SI B11 01 04
Engine

Heated Wrap for Crankcase Vent System

E53 X5 with M62 engine from start of production through 9/2003.

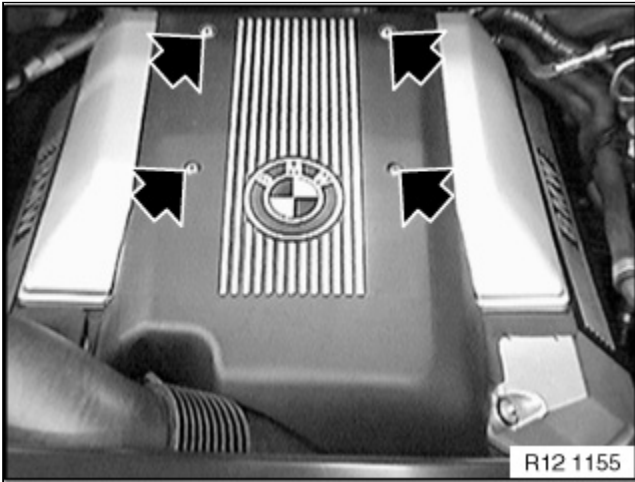
During periods of driving in extreme cold weather conditions, certain X5 vehicles may experience misfiring, blue smoke from the exhaust, high oil consumption/oil loss or engine damage.

Condensation in the crankcase vent system could freeze, causing higher than normal crankcase pressures. In extreme cases, this could cause engine oil to be introduced into the intake manifold and then into the combustion chambers. Should sufficient oil quantities enter the cylinders, engine damage could result.

Install a heated wrap kit around the crankcase vent hoses.
